Access Compliance Report

Public Rights-of-Way

(Curb Ramps)

Intersection ID: N/A	Main Street: INVERNESS_BAY_RD	Cross Street: ELGIN_MOOR_RD	Location: NE
ADA ID: 64C921CE649E	Ramp Type: Perp	Initial Pass/Fail: Fail	Overall Compliance: No
Severity Score: 22.5			
Codes/Mitigation Info/Possible Solution		Field Measurements/Component Compliance

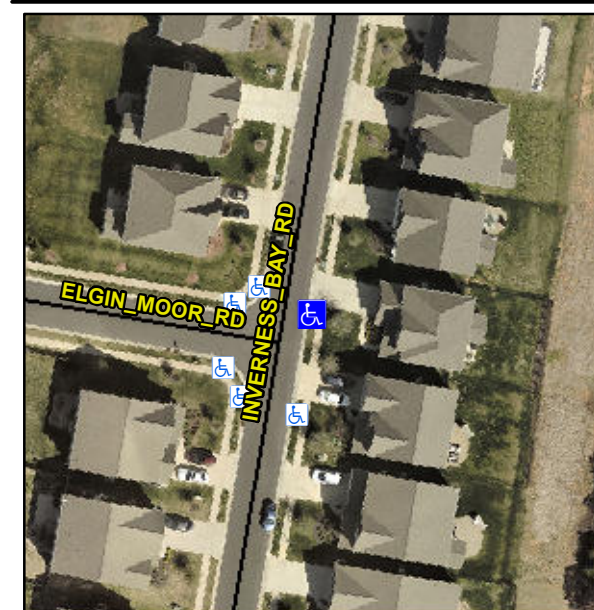
Not Found, R304.5.1, R304.2.2

Compliance	Description	Data	Compliance	Description	Data
N/A	Ramp Length (in)	48.0	No	Ramp Slope (%)	8.6
No	Ramp Width (in)	46.5	Yes	Ramp XSlope (%)	2.3
N/A	Flare Type LT	N/A	N/A	Flare Type RT	N/A
N/A	Flare Slope LT (%)	N/A	N/A	Flare Slope RT (%)	N/A
N/A	Flare Traversable LT?	N/A	N/A	Flare Traversable RT?	N/A
N/A	Landing Length (in)	N/A	N/A	DWS Provided?	N/A
N/A	Landing Width (in)	N/A	N/A	DWS Contrast?	N/A
N/A	Landing Slope (%)	N/A	N/A	DWS Length (in)	N/A
N/A	Landing X Slope (%)	N/A	N/A	DWS Full Width?	N/A
N/A	Landing Curb? (Y/N)	N/A	N/A	DWS Offset (in)	N/A
N/A	Shared Landing?	N/A			
N/A	Gutter Ponding?	N/A	N/A	Gutter Slope (%)	N/A
N/A	Gutter Lip Ht (in)	1.0	N/A	Gutter X Slope (%)	N/A
N/A	Painted X Walk1?	No	N/A	Painted X Walk2?	N/A
	X Walk 1 Direction	To NW		X Walk 2 Direction	N/A
N/A	X Walk 1 Width (in)	N/A	N/A	X Walk 2 Width (in)	N/A
	X Walk 1 Slope (%)	0.6		X Walk 2 Slope (%)	N/A
	X Walk 1 X Slope (%)	3.3		X Walk 2 X Slope (%)	N/A

Remove & Replace Entire Ramp.
